# Running changes in 1964 Corvair Cars

This is a work in progress which attempts to document known running changes in Corvair cars for the 1964 model year. I am not noting changes in specifications or part numbers, just changes that affect the appearance or operation of the vehicles. I attempt to indicate the approximate date that such changes took place, based on my own research of original cars and study of documents, but I indicate with a question mark when I am uncertain or more study is needed. Photos of before and after changes are imbedded in the document.

09C Trunk Lid with push-in letters

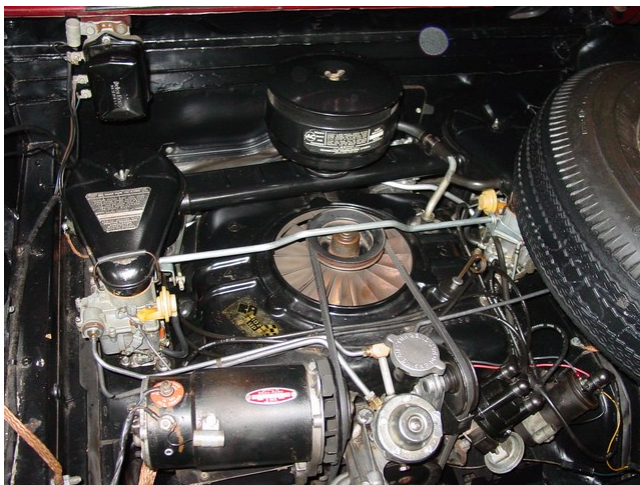
**12B? Trunk Lid Letters:** The C O R V A I R letters on the trunk lid were initially of the push-in style (same as on the Deck lid), but due to issues with water getting under them and causing rust, were converted to screw-in style sometime around mid-December of 1963. We have found some cars with later build dates (up to 02D) with the push-in style, but no cars earlier than 12B with the screw-in style. It's thought that the changeover probably occurred around 12B but excess inventory was used up on a few later builds.

04A Trunk lid with screw-in letters

01C Deck Lid with 8 drain holes and shorter weatherstrip

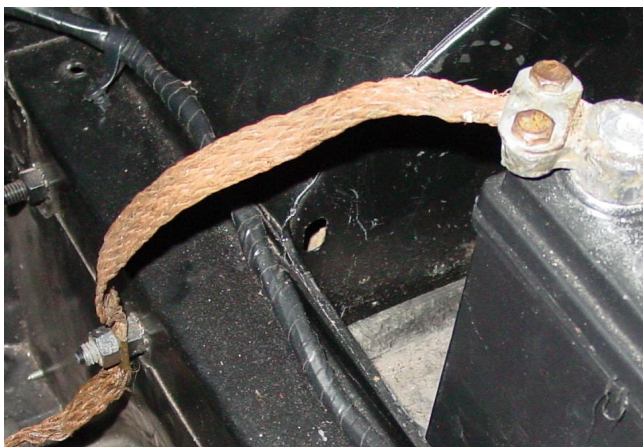
**02A? Deck Lid Vents and Weatherstrip:** Modification made to the rear under end of the Deck Lid to close off 6 of the 8 drainage holes and elongate the rear weatherstrip to reduce the likelihood of tailpipe emissions being drawn back into the engine compartment. The earliest car I've seen with this change has body code 02A, with some as late as 04A still with the original style.

04A Deck Lid with 2 drain holes and longer weatherstrip
